Technical Service Bulletin									
Date Issued	Model Year(s) Affected			Model(s) Affected		TSB #			
12/17/2010	2008-2010			Dutch Star, Dutch Aire, Mountain Aire		378			
Brand						Type			
All <input type="checkbox"/>	American Star <input type="checkbox"/>	Mountain Aire <input type="checkbox"/>	All <input type="checkbox"/>	TT <input type="checkbox"/>					
Cypress <input type="checkbox"/>	Dutch Star <input checked="" type="checkbox"/>	Kountry Aire <input type="checkbox"/>	FW <input type="checkbox"/>	CA <input type="checkbox"/>					
Northern Star <input type="checkbox"/>	Kountry Star <input type="checkbox"/>	Essex <input type="checkbox"/>	DP <input checked="" type="checkbox"/>	DB <input type="checkbox"/>					
Scottsdale <input type="checkbox"/>	King Aire <input type="checkbox"/>	Dutch Aire <input checked="" type="checkbox"/>							
All Star ME <input type="checkbox"/>	Ventana <input type="checkbox"/>	Bay Star <input type="checkbox"/>							
<table style="width:100%; border: none;"> <tr> <td style="width: 50%; vertical-align: top;"> <input type="checkbox"/> Air Conditioning & Heating <input type="checkbox"/> Appliances & Accessories <input type="checkbox"/> Cabinets & Furniture <input

FIG. 3-1

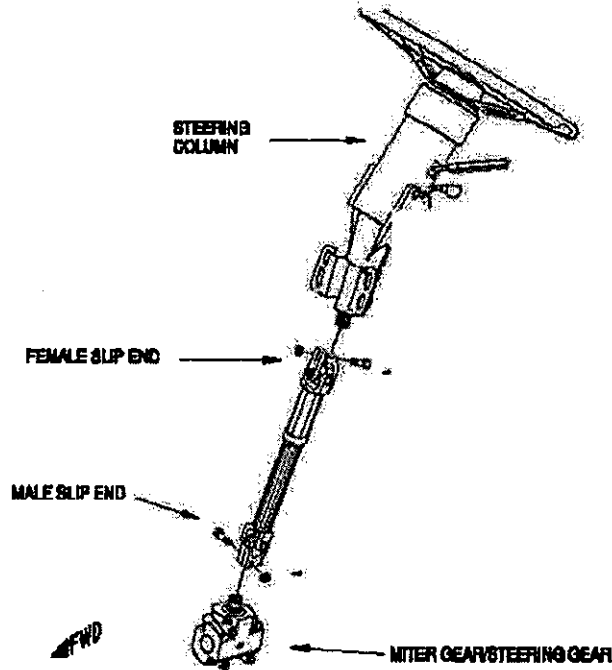
CAUSE: On certain intermediate steering shafts, circumferential weld beads fusing the splined shaft to the intermediate shaft may have been mislocated potentially reducing the torsional and axial load capacity of the shaft.

CORRECTION: **Inspect the affected shaft as required.** Replace steering slip shaft as necessary.

4. Center steering wheel prior to removing the steering slip shaft.
5. Remove clamp at the top of the steering column rubber boot located at the bottom of the steering column going to the floor to gain access to the pinch bolt located at the top of slip shaft. Retain clamp for reuse.
6. Refer to FIG. 3-1. Remove pinch bolt at steering column end of steering slip shaft. Properly discard hardware.
7. Refer to FIG. 3-1. Remove steering slip shaft from bottom of steering column.

8. Refer to FIG. 3-1. Remove pinch bolt at gear box and or miter box end of steering slip shaft. Properly discard hardware.
9. Refer to FIG. 3-1. Remove steering slip shaft and retain to ship back to Spartan Motors Chassis, Inc.

10. Refer to FIG. 3-1. Install new slip shaft in reverse order using new hardware. Torque bolts to proper values listed in service kit information on pages 1 and 2.
11. Reinstall rubber boot and clamp. Secure as needed.
12. If any power source was disconnected reconnect power source.
